## Purpose

This bulletin advises owners and operators of UP boilers to inspect for cracks in tube panel membranes and tubes located near the junction between boiler sidewalls and the pendant superheater floor.

Figure 1 Area affected by superheater floor tube cracking and failures.

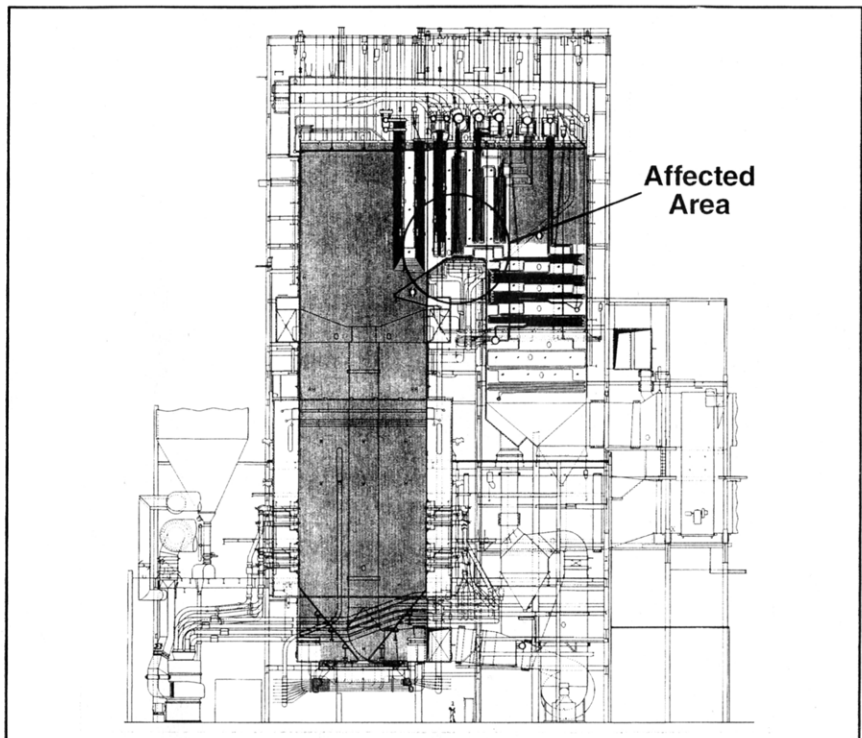
Cracking has been found in the floor membrane near the boiler sidewalls. Figure 1 shows the general area where cracking has occurred. The construction of the floor-to-wall connection at the floor tube bends is relatively stiff. Therefore, the locations between the sidewall tubes and the superheater floor are the most prone to membrane cracking (shown in Figure 2). During rapid unit start-up and shutdown (see PSB-20), the thermal gradients generate sufficient stresses to form cracks in the floor membrane near the sidewalls, and high stresses in the side wall tubes. These cracks can propagate into the tube wall, resulting in leaks.

Closely examine the floor tubes and membrane near the floor-to-wall junction for cracks. If membrane cracking is found, repair or replace the membrane. If cracking has propagated into the tube metal, replace the affected tube(s). The floor tube membrane should be slotted at the location shown on Figure 3 for a distance of approximately four feet centered on the tube bend (see Figure 2, Locations 1 and 2). All slots should start and
